KENWOOD

ASB-1024

Service Bulletin

Subject: TS-950S/SD Transmit Spur
1993

**AF Unit (X49-3020-00)
Foil Side View**

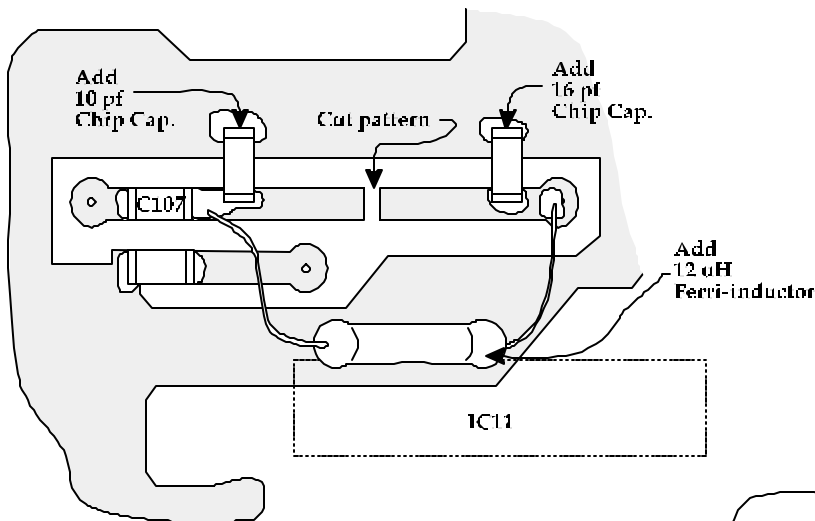
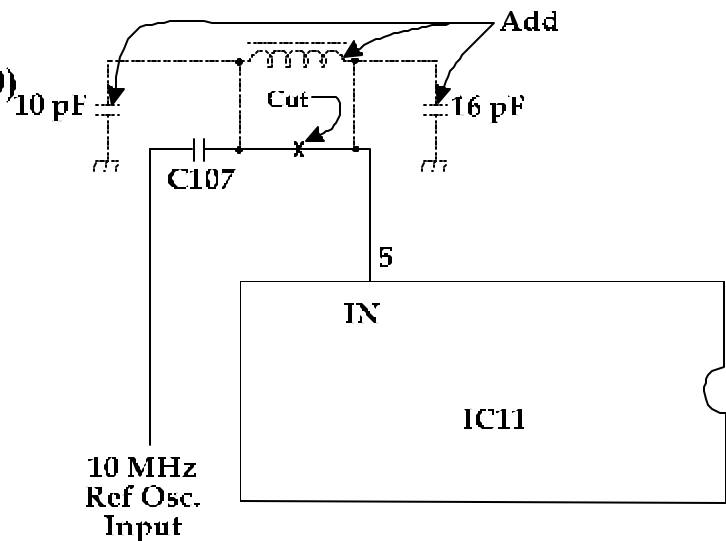
A transmitter spur might be present at a dial frequency of XX.XX1 MHz. This spur is quite small but might become noticeable when the transceiver is used with a linear amplifier.

The transmitted signal enters pin 5 of IC11 which is in the last PLL loop in the AF unit due to RF feedback. This pin is the input for the 10 MHz Ref Osc signal from the CAR unit. IC11 is the source of the spurious signal since both the band and 10 MHz frequencies are divided by the 500 kHz comparison frequency supplied by IC11.

To reduce this RF feedback increase the Ref Osc level from .2V to .7V rms by adding the accompanying circuit to the input of IC11.

Qty	Description	Kenwood Part No.	Circuit Description
1	12 uH Ferri-inductor	L40-1201-17	NA
1	10 pF Chip Cap	CC73FCH1H100J	NA
1	16 pF Chip Cap	CC73FCH1H160J	NA
